## **ADVERSE TSUNAMI IMPACTS RELATED TO THE DEIR/DEIS'S PROPOSED MODIFICATIONS OF THE BALLONA WETLANDS ECOLOGICAL RESERVE**

Prepared by David DeLange, PhD, and Mansour Rahimi, PhD  
for the Sierra Club  
January 31, 2018

Exhibit 1

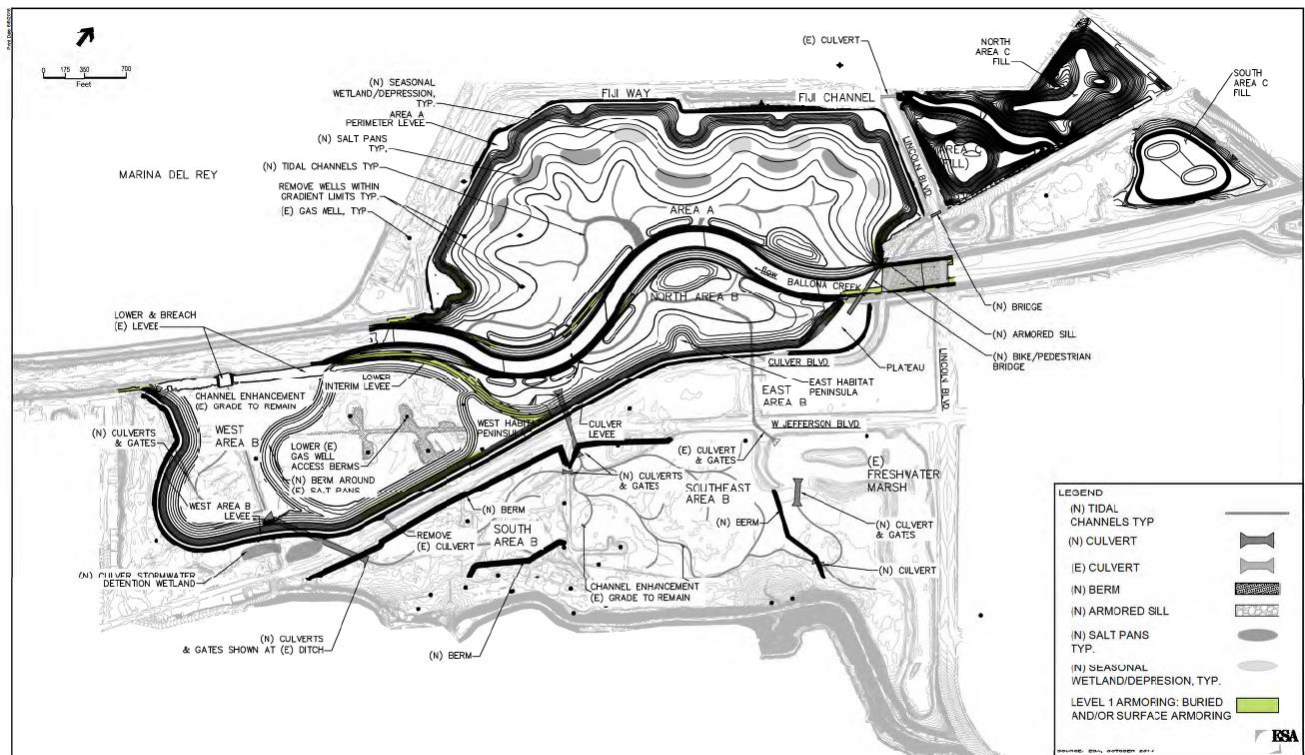
The most prominent structural component of the project proposal consists of five approximately 20 feet tall armored levees, all of them west of Lincoln Blvd (“Main Levee System”, Exhibit 1). The first of these, the Fiji Way levee in Marina del Rey, would run from near Lincoln Blvd, seaward along Fiji Way and Area A, before curving southward, then ending near/at the north side of Ballona Creek. The second, more southerly Culver Blvd. levee in Playa del Rey, would begin somewhat west of Lincoln Blvd. and run seaward along the north side of Culver Blvd, before curving northward and ending at/near the south side of Ballona Creek just across the creek from the seaward most terminus of the Fiji Way levee.

Our analysis will show that 100-year tsunami waters predicted by DEIR sources (correctly reanalyzed) will encounter the DEIR’s Main Levee System, resulting in flood levels surrounding the levees that are higher than would occur in the absence of this Main Levee System. This increased flooding will occur in important part because the tsunami waters from the Pacific Ocean—waters that would currently flow straight ahead, discharging across the 400-meter-wide part of the wetlands immediately bordering Ballona Creek—such waters would instead be redirected by the Coast-facing Levee System toward the north along Fiji Way and toward the south along Culver Blvd. Both Fiji Way and Culver Blvd. are designated tsunami escape routes and, in fact, the only such escape routes available to approximately one thousand people. The increased tsunami water levels resulting from this redirection of water will also reach and adversely impact, more generally, the populated areas to the north, south and west of the Main Levee System and also the populated area immediately north of the Fiji Ditch.

- One of the most prominent structural components of the proposed project (Alternatives 1&2) consist of a main levee system (Exhibit 1). The proposed levee system is designed to protect the low-lying areas and other structures (e.g., roads) from potential flooding of the Ballona Creek (e.g., DEIR pages 3.9-67, 3.9-76, 3.9-77). To provide this protection, the levees are being designed at significant heights.
- Under Alternatives 1 & 2, Culver Blvd will be protected by two levees, stretching along its north side and its south side., two more levees running along Ballona Creek, and a levee running along

Exhibit 2

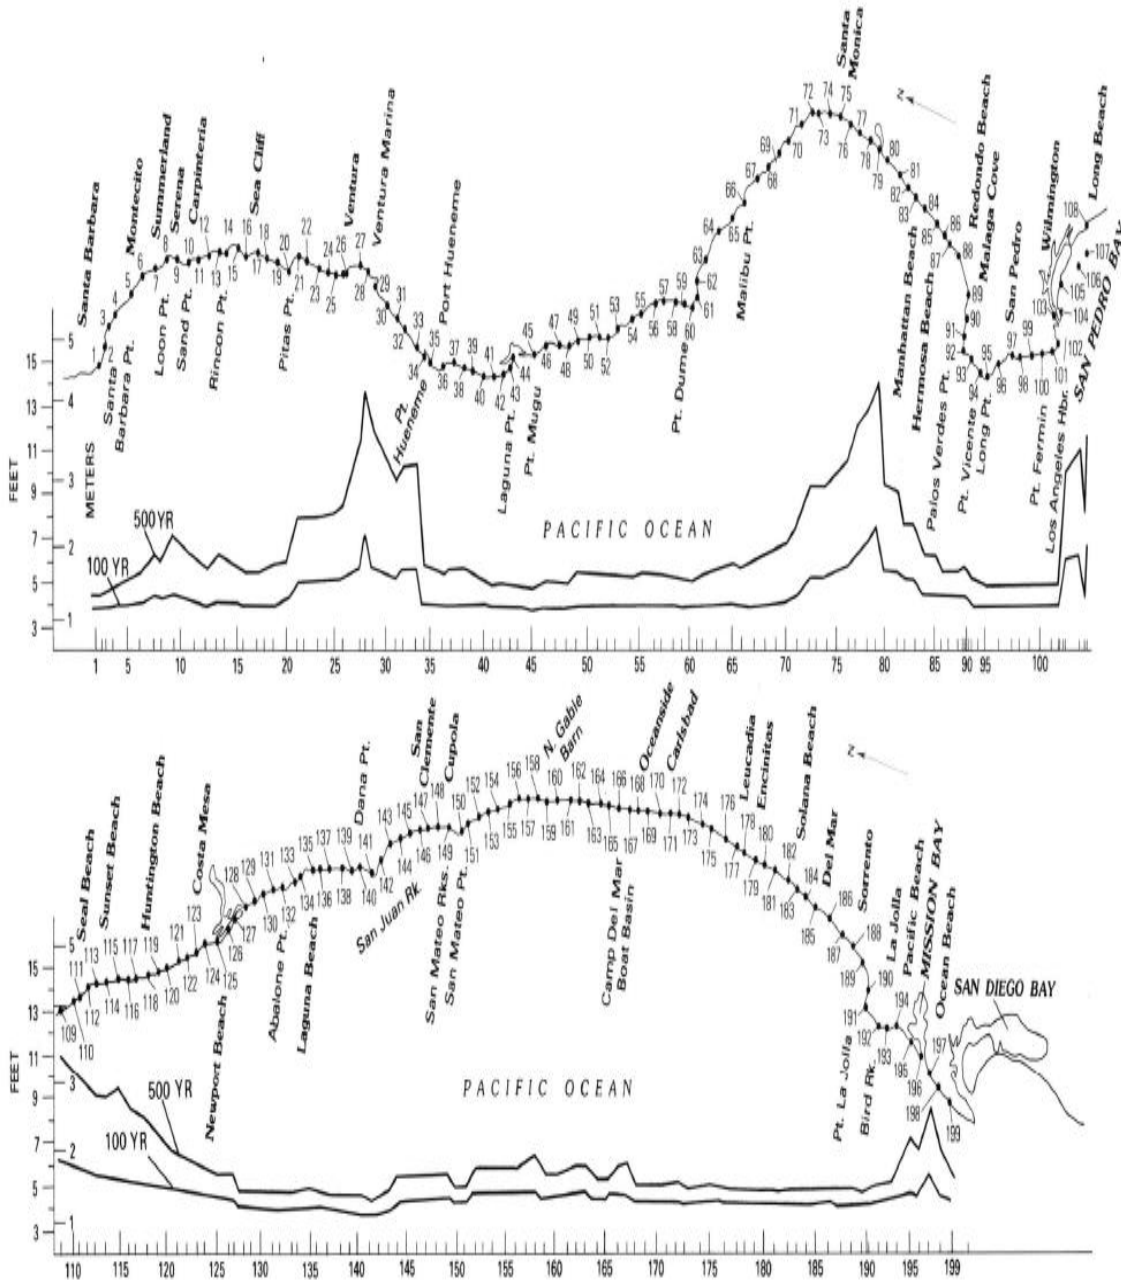
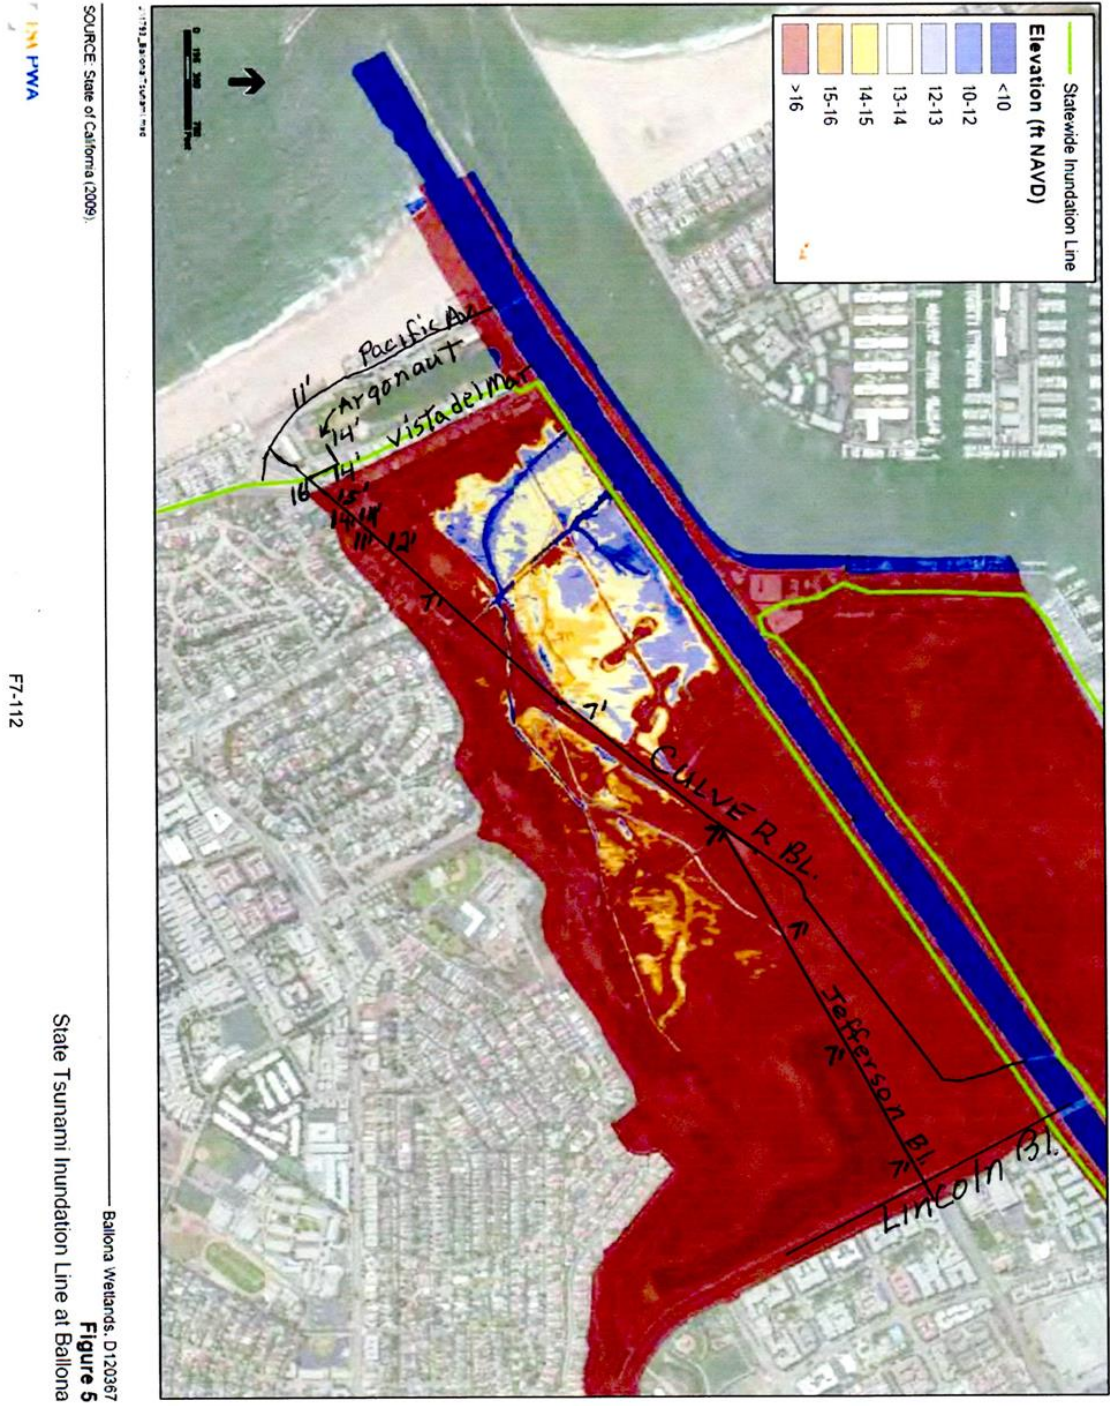
There are a number of fundamental problems with this analysis. First, the DEIR cites only the outdated 1985 Ziony report to support this prediction of a **5-foot** 100-year tsunami run-up<sup>1</sup> However, the DEIR is incorrect. The Ziony report nowhere in its 521 pages asserts or implies a 5-foot run-up for a 100-year tsunami at or near Ballona. Instead, in the attached Figure 208 (locations 79-80) copied from Ziony’s report, Ziony predicts a **9-foot** 100-year run-up for the project area (Exhibit 2)<sup>2</sup>

The Ziony report's conclusion of a 9-foot 100-year run-up is reinforced by Los Angeles County Board of Supervisor’s certification, in the Marina del Rey Land Use Plan, of a J.H. Wiggins finding of a 9.6 foot expected 100-year run-up at Venice Beach (Venice Beach reaches the northern edge of the project area.)<sup>3</sup> This Land Use Plan further clarifies Wiggins’ analysis as follows: “the predicted heights are not maximum credible heights and do not presume coincidence of the highest tsunami wave with peak high tied or with storm induced high-water setup and superimposed storm waves....”<sup>4</sup> In other words, the predicted 9.6-foot predicted run-up, as with the DEIR's Ziony source<sup>5</sup>, is a **minimum** expected run-up occurring during calm seas and not during high tide.

Returning then to the DEIR's Ziony report, if we add in the assumption of high tide, then, following the DEIR analysis above, which for high tide adds 6 feet above the mistakenly posited run-up of 5 feet, we arrive at a (recalculated) predicted minimum **15-foot** run-up at highest tide (i.e., 9' + (11'-5')) for a 100-year tsunami run-up at Ballona. Again, this conclusion is based entirely on recalculating corrected data from the DEIR and its sources. Furthermore, high tides will often be even higher than the 6 feet posited here as can be seen from 2018 Santa Monica Bay high tide charts.<sup>6</sup>

Exhibit 7

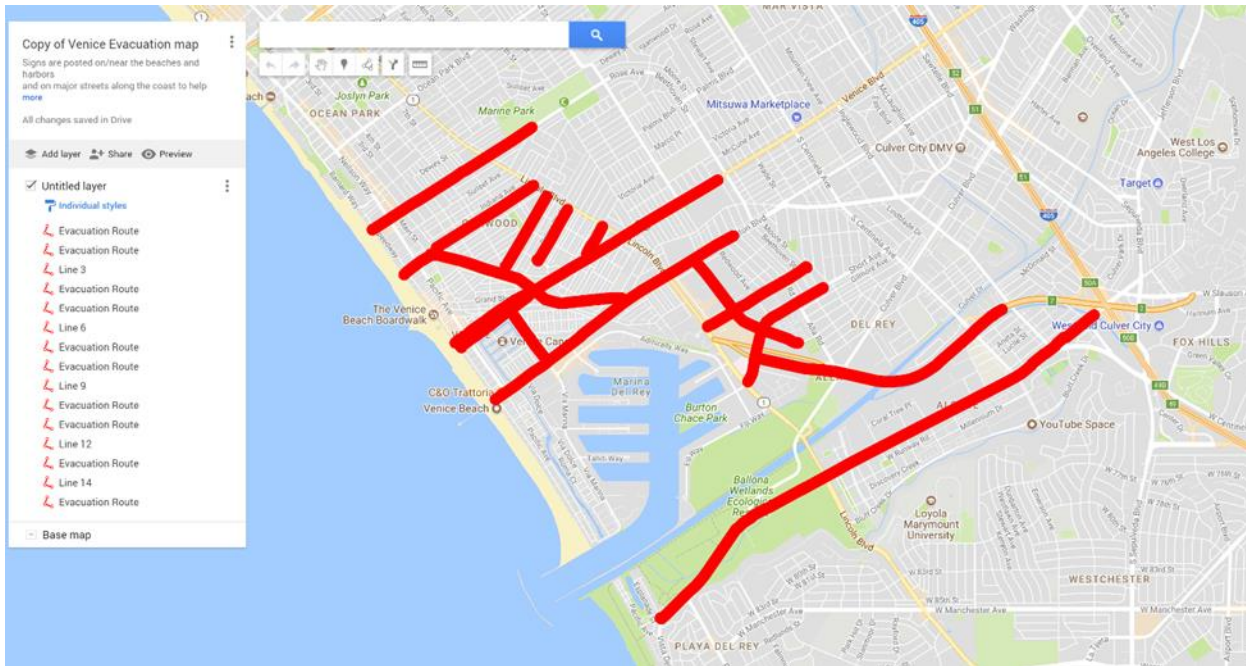
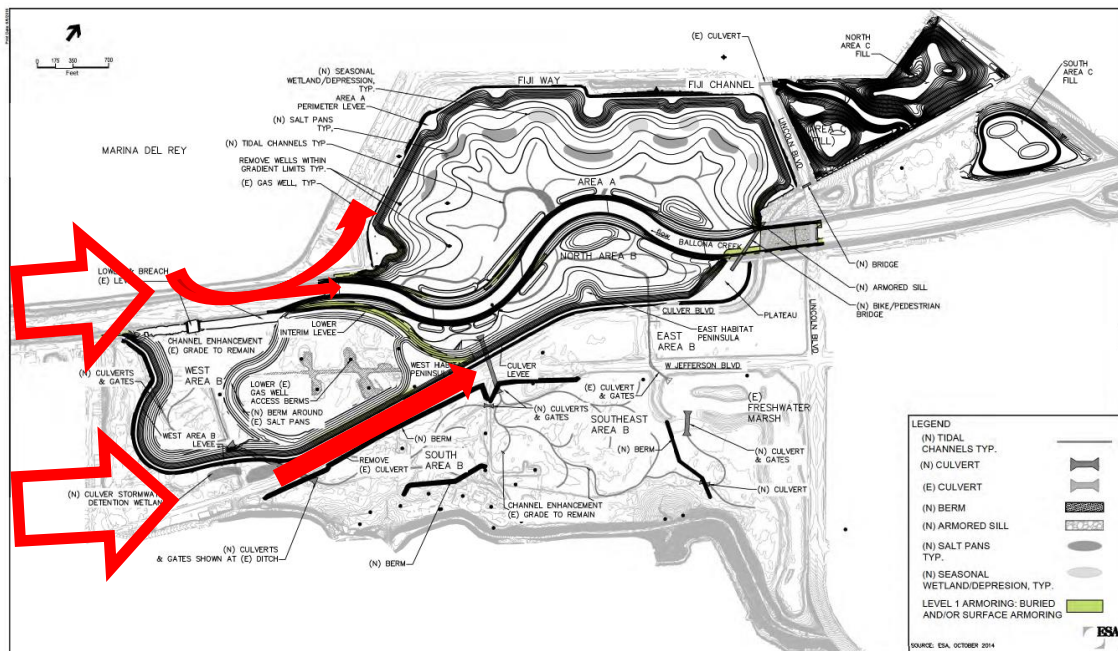
- The Playa Del Rey bluffs, stretching across the entire south side of the proposed project area are over 150 feet high.
- The Los Angeles County Office of Emergency Management has designated Culver Blvd as the only tsunami evacuation route out of the Playa del Rey side of the Ballona area. See below for a map of the county designated tsunami evacuation routes in the Marina del Rey and Playa del Rey areas (Exhibit 7). Populated Culver Blvd. is the most southern route between the Ballona Creek and the Playa del Rey bluffs. Besides, populated Fiji Way, alongside the northernmost levee is especially vulnerable to tsunami flooding (DEIR Map in Exhibit 3 and Exhibit 8)
